Response to Submissions

Blayney Quarry

R.W. CORKERY & CO. PTY. LIMITED

March 2019

Figure 2
CONSTRUCTION NOISE SCENARIO 2

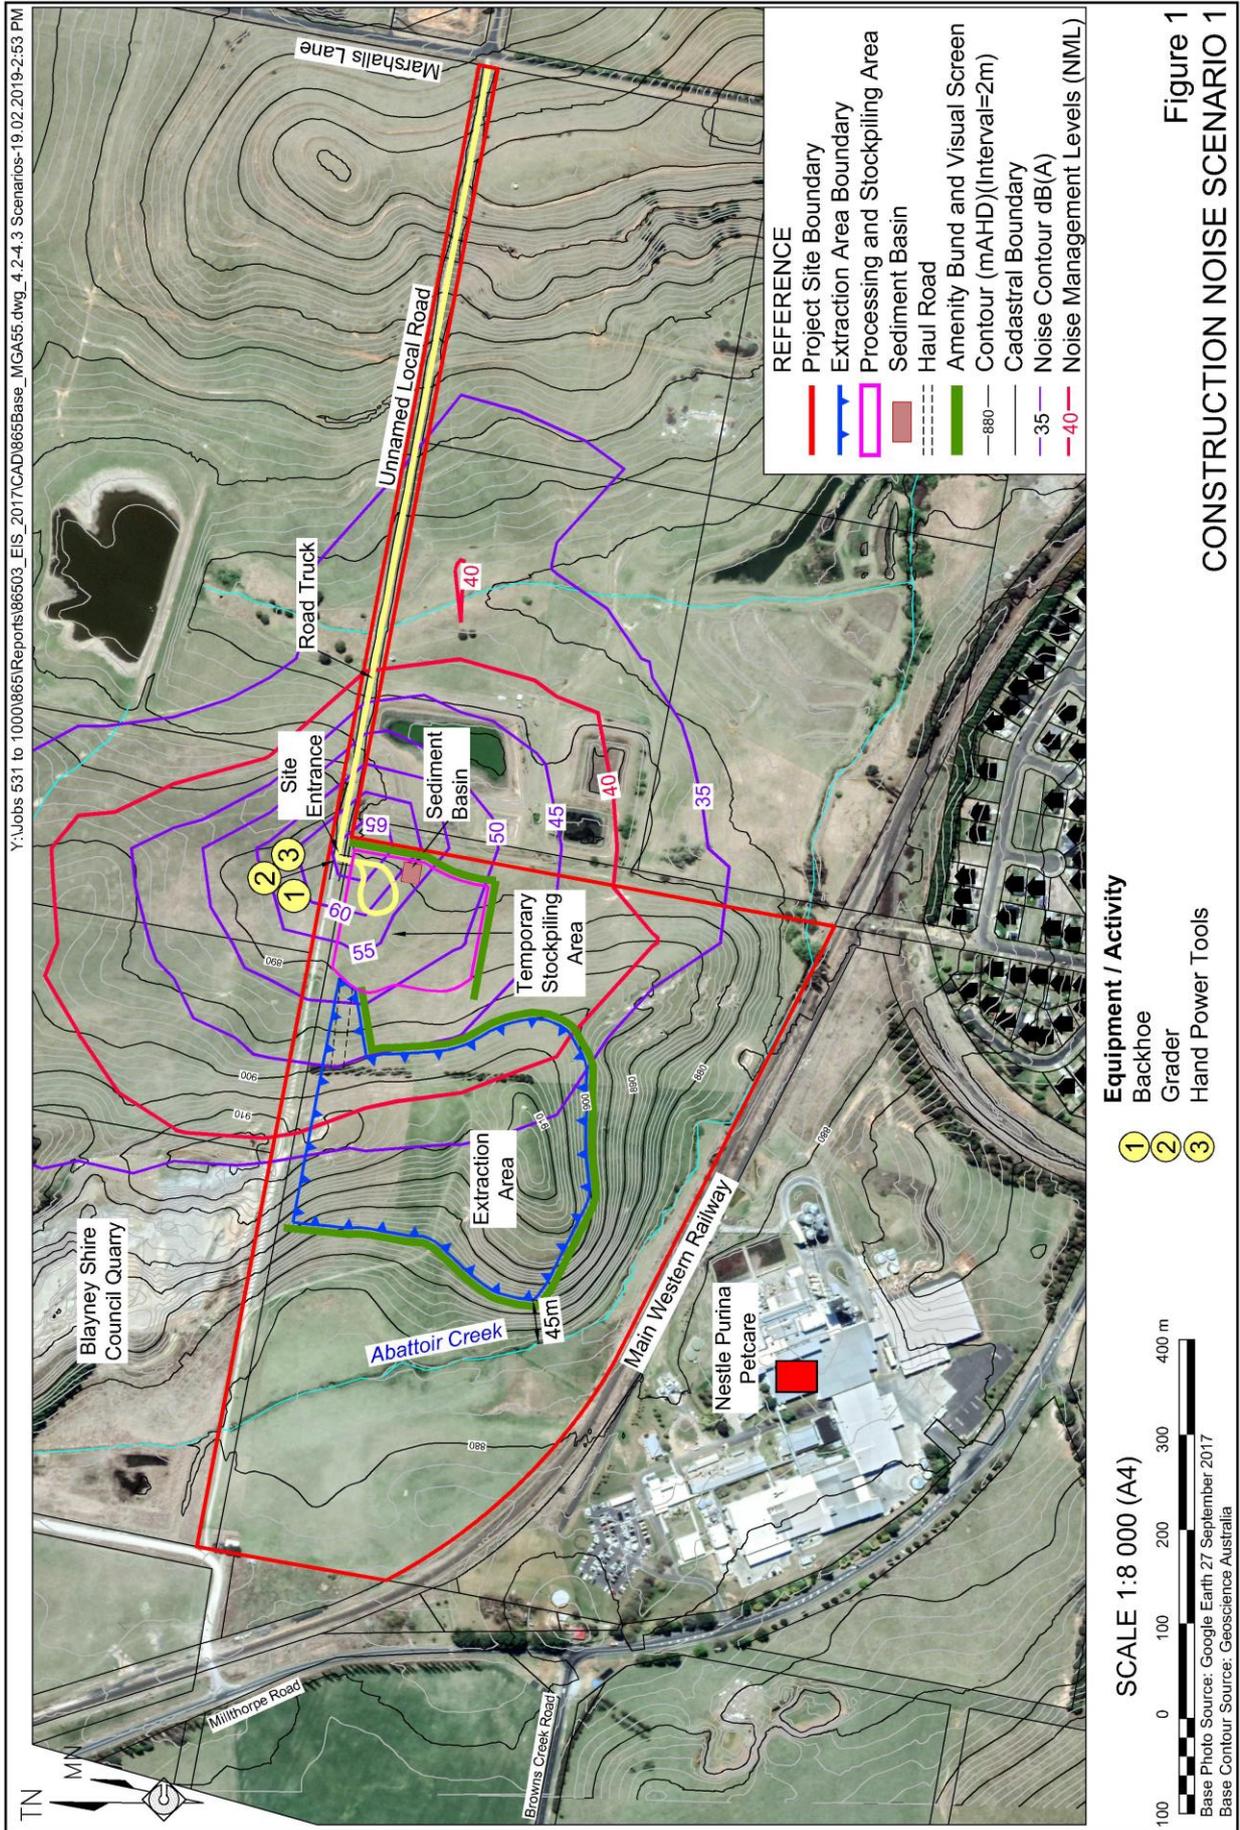
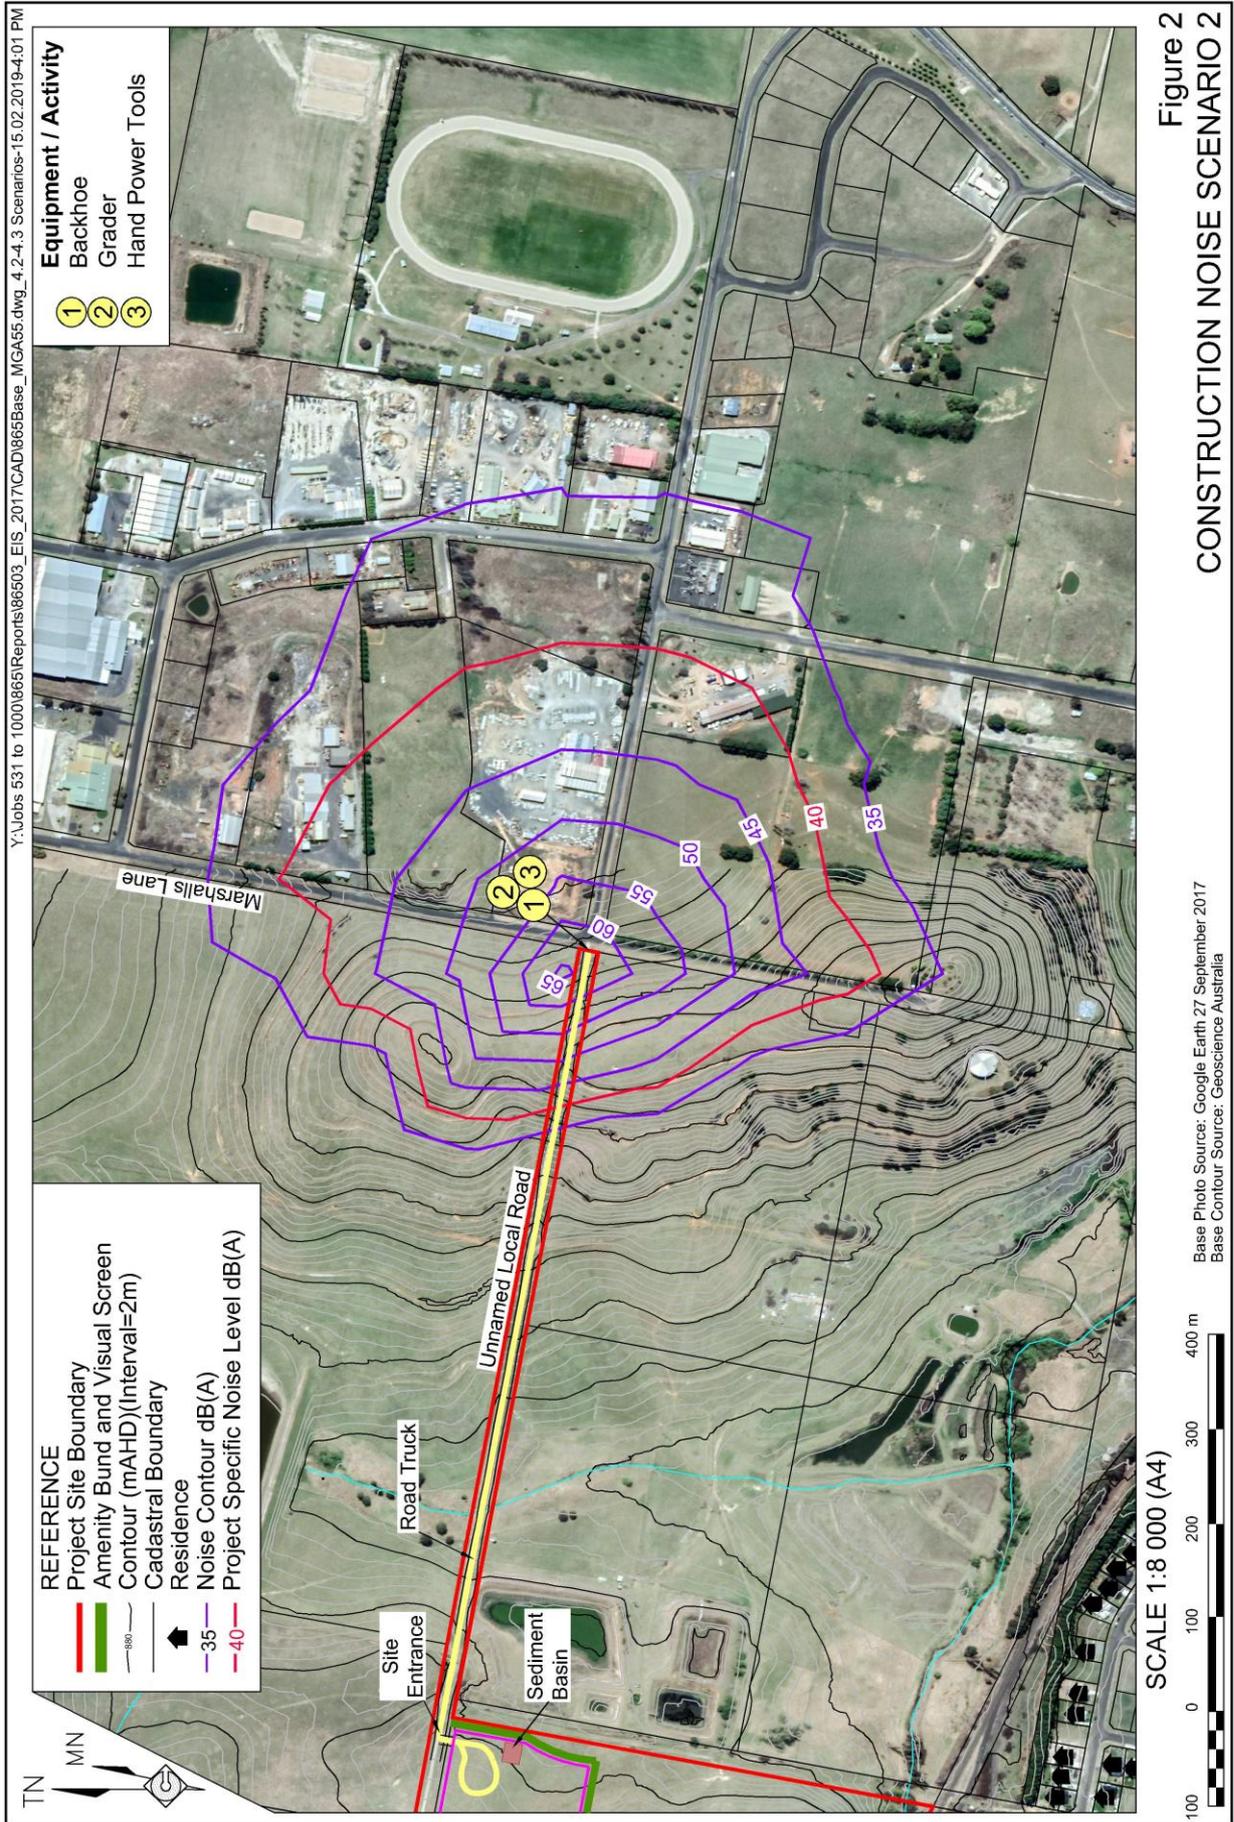
There is only one construction scenario with plant located close to the site entrance and a road truck as a line source. It is considered that other construction scenarios should be provided to show the typical worst case predictions at each receiver in relation to the access road. For example, the building of the amenity bund is recommended, including any cumulative impacts from contemporaneous road and bund construction to confirm criteria are achieved.

In summary, noise emissions associated with both Construction Scenario 1 and 2 would be less than 40dBA at all surrounding residences. In addition, the Applicant notes that construction operations on the Site Access Road would be expected to be completed in a relatively short period, with noise emissions following completion of the works limited to operational vehicle movements assessed under Operational Noise Scenarios 1 and 2 in RWC (2018).

Figure 4: Blast locations around the proposed quarry perimeter (B1 to B4) used to illustrate closest proximity to sensitive residential receivers (R1, R2, R6, R14)

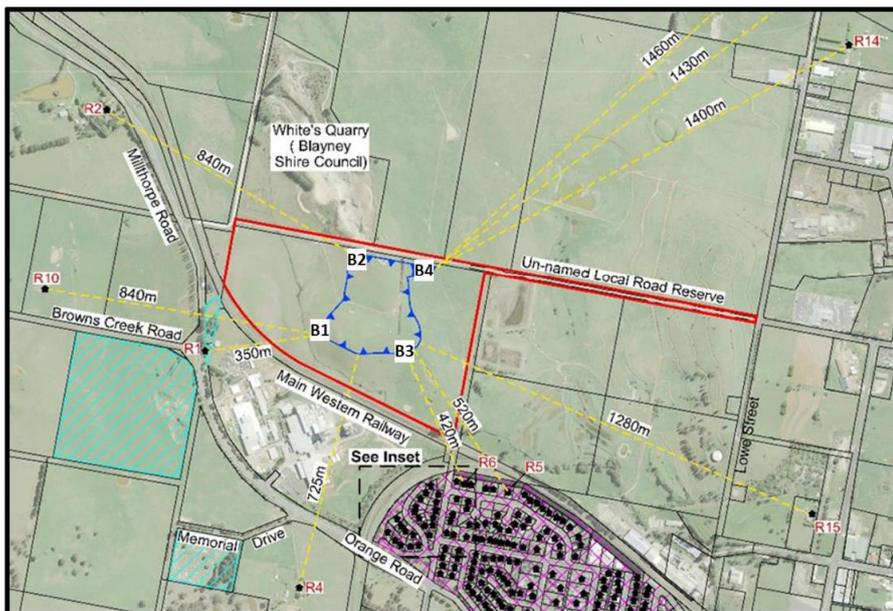
- *The Proponent demonstrate that blast impacts be capable of complying with the guidelines contained in Australian and New Zealand Environment Council – Technical Basis for guidelines to minimise annoyance due to blasting overpressure and ground vibration (ANZEC, 1990).*
- *The proponent provide a quantitative assessment of proposed predicted ground vibration and blast overpressure impacts to demonstrate compliance with ANZEC guideline criteria at residential locations and locations where ground vibration and overpressure can affect people based on the assumed blasting schedule.*

Blast locations 1 to 4 have been used to represent examples of the closest blasts around the perimeter of the proposed quarry, to residences R1, R2, R6, R14, as worst-case scenarios (Figure 4). The estimated 4mm/s ground vibration contour for these scenarios is shown in Figure 5, where small scale 76mm diameter blastholes are used, with a maximum charge of 45kg/hole for ANZEC compliance. The major constraints of blasthole diameter and maximum charge for a range of distances are also illustrated graphically in Figure 7, as distance between the blast and nearest residence increases.

Updated Site Access Road Concept Designs

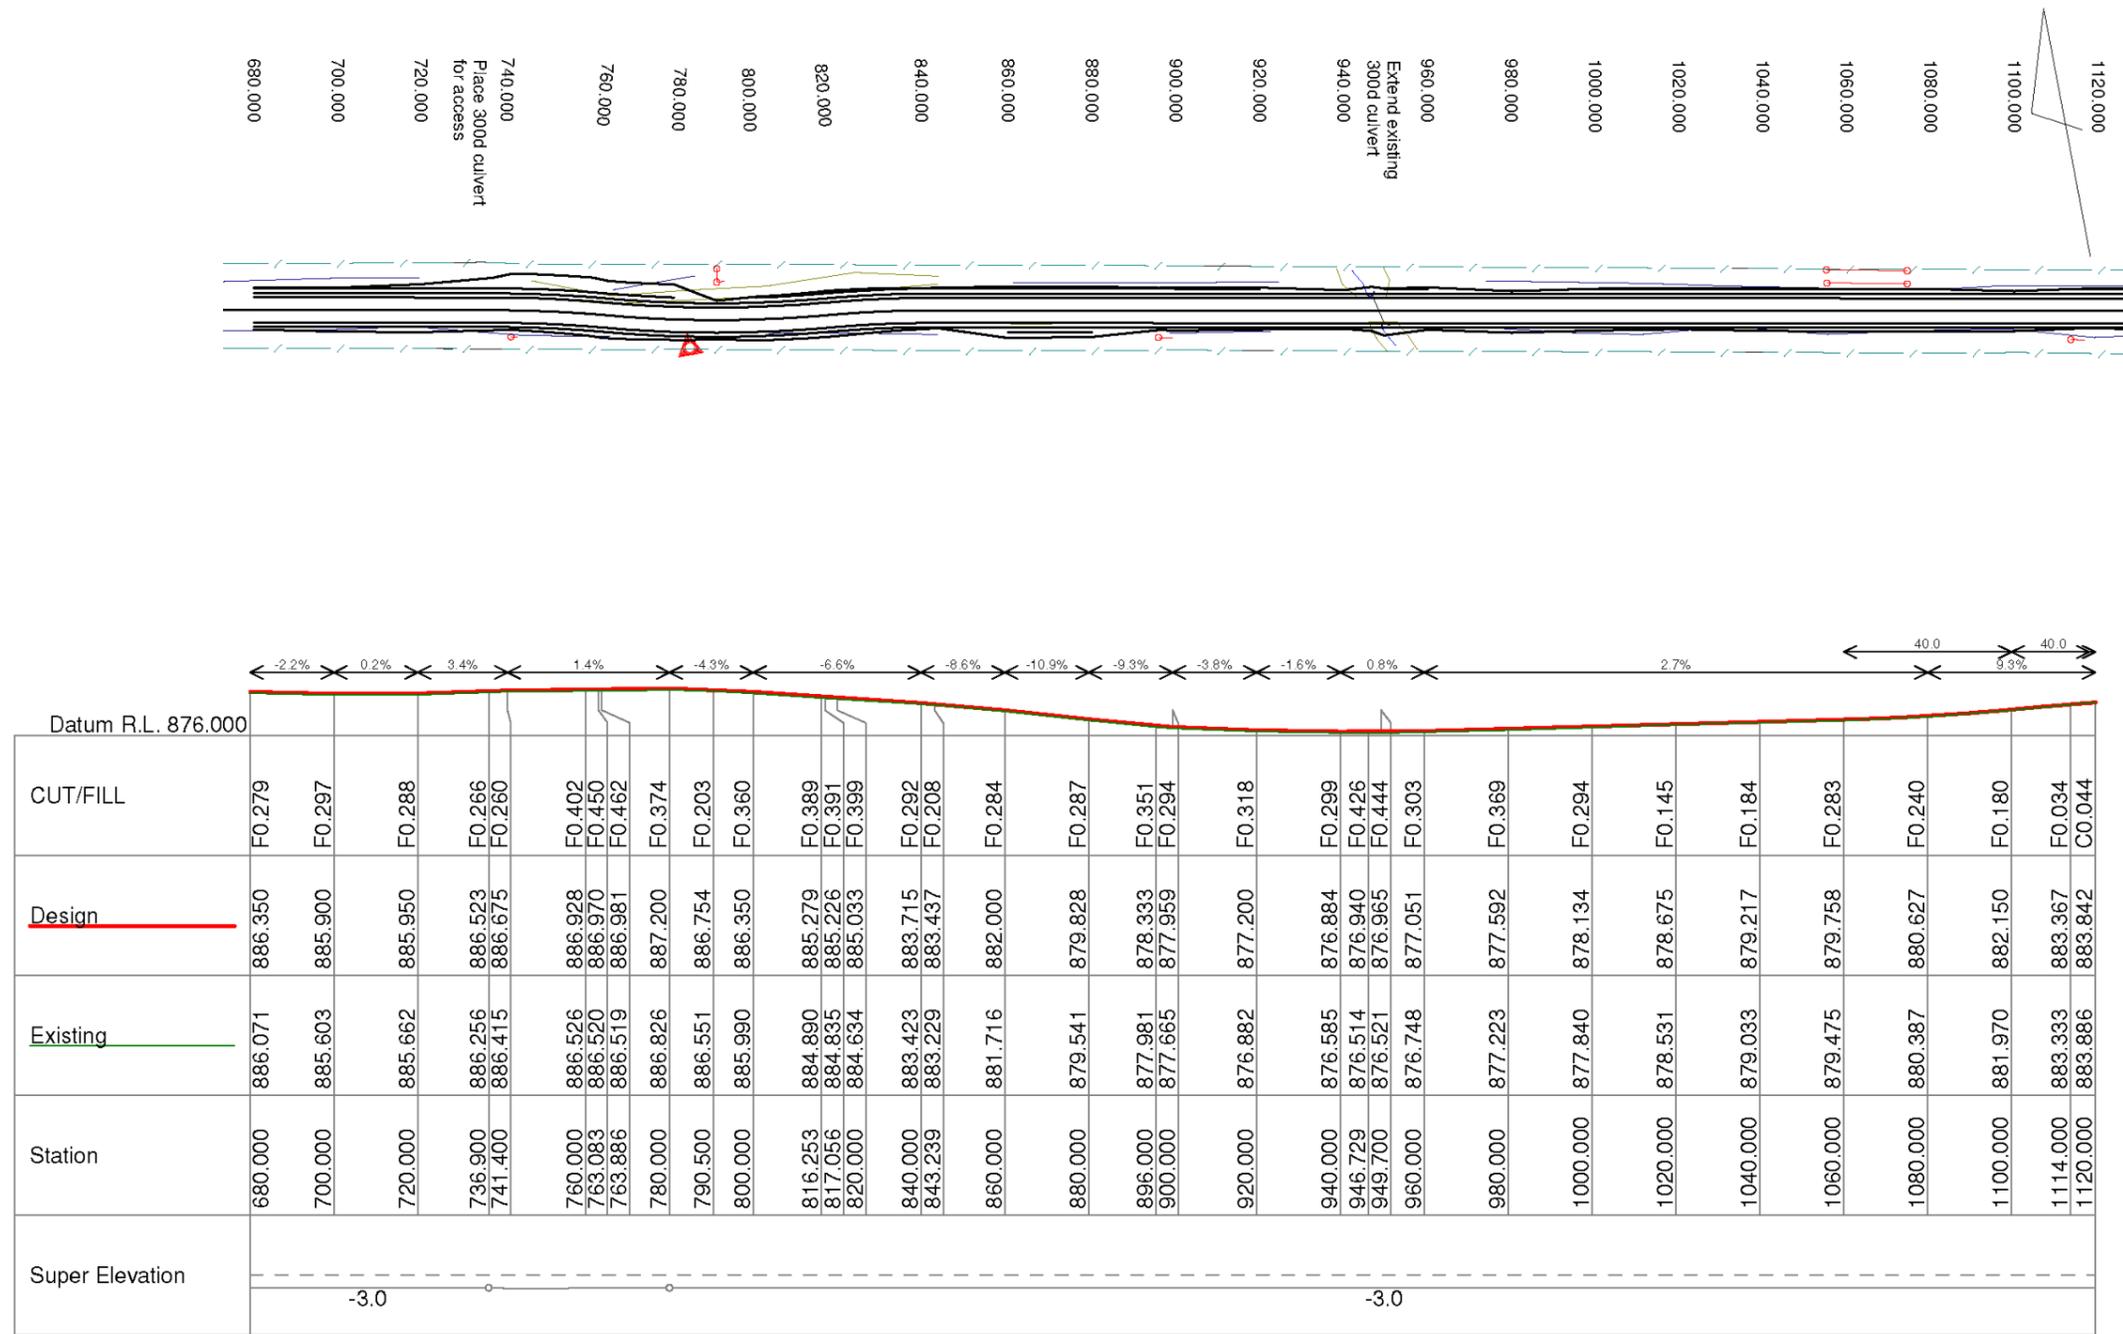
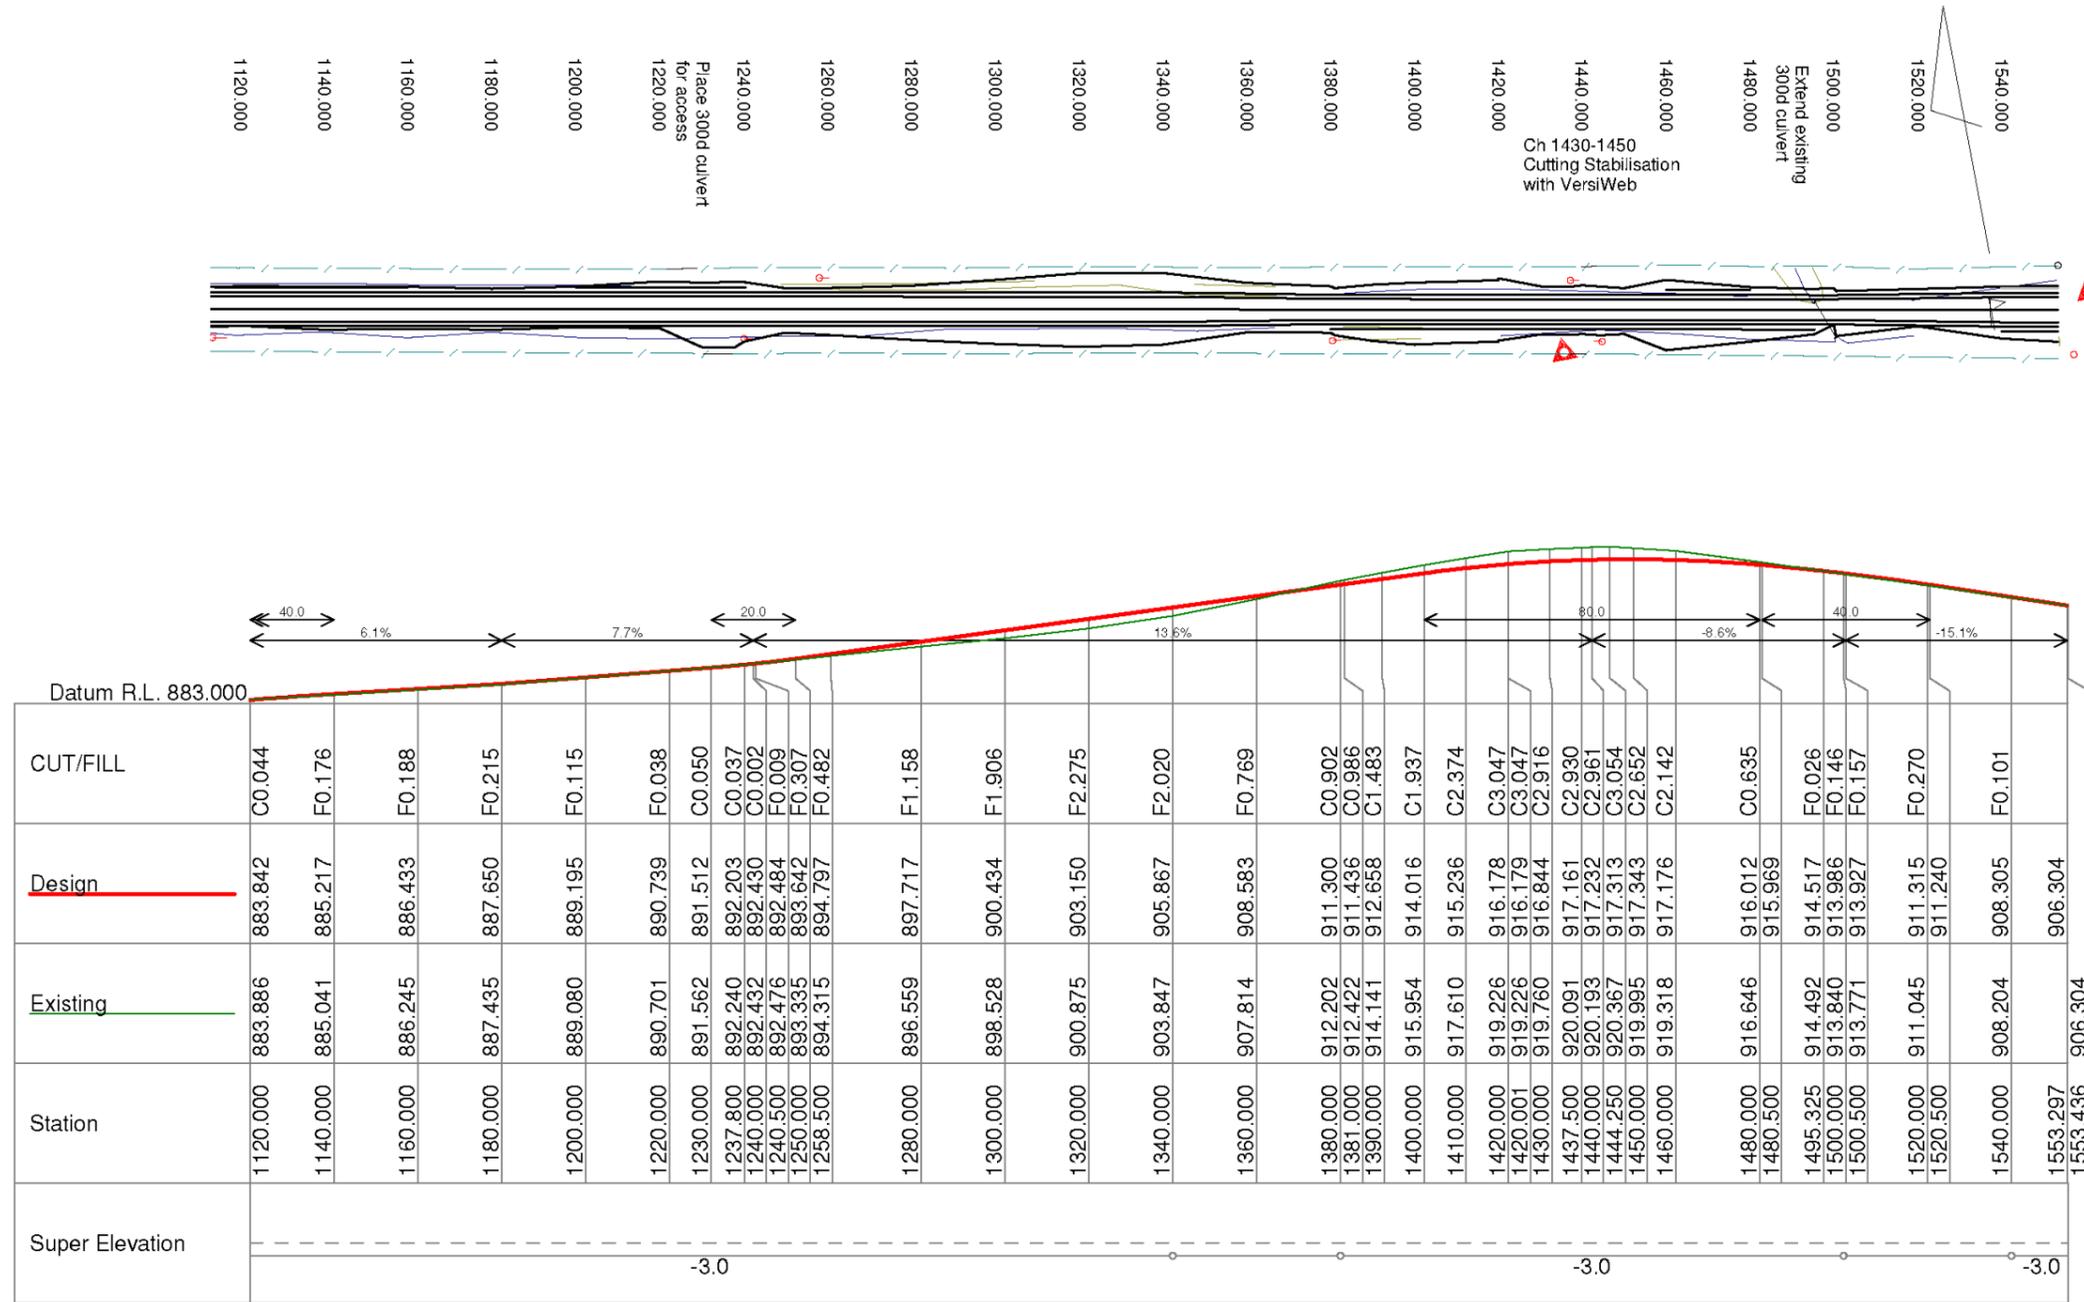
If the applicant believes that the development complies with ISSC20 then please provide plans certified by a suitably qualified person (showing distances from the proposed development to Essential Energy's infrastructure) together with any other relevant information for further consideration.

Appendix 2 presents updated concept plans for the Site Access Road, prepared by Duncan Priestly Civil Engineering. In preparing those plans, Mr Priestly was provided with copies of the above guidelines and the concept plans include a depiction of the “no dig zones” associated relevant power poles.
